Re: **ADDENDUM NO. 6**
20-028.1 – Construction of PhilaPort Distribution Center New Dry Warehouse

This Addendum No. 6 is issued to:

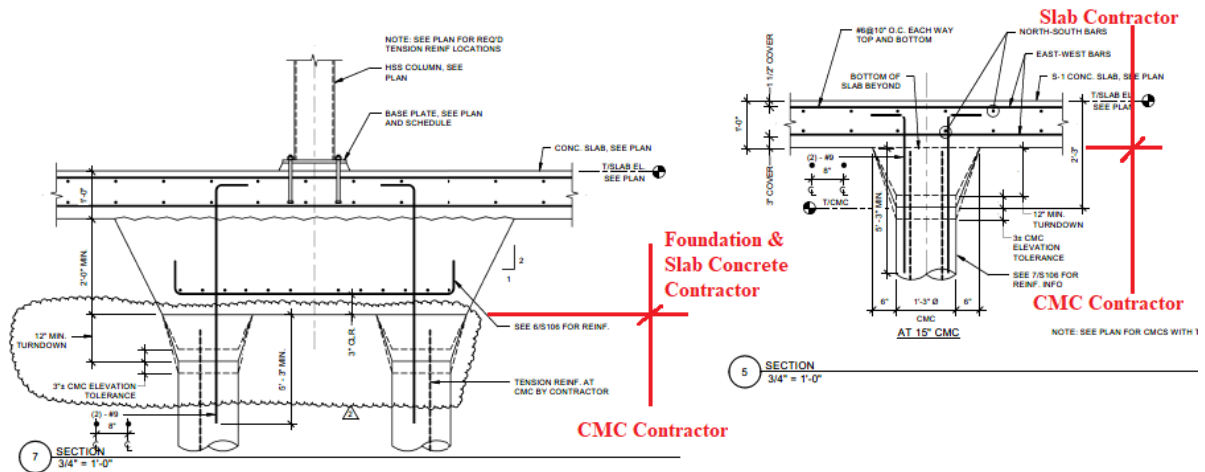
Q72: Please clarify selections for the ceramic tile in the office space. No description of WT-1 is given and FT-1 is outdated

Floor Tile (FT-1)
Manuf.: Crossville
Style: Cross Colors Mingles
Color: Graphite Unpolished
Size: 12x12
Grout: Mapie Charcoal #47
Joint: 3/16"

Note that the wall base in restrooms should match WT-1
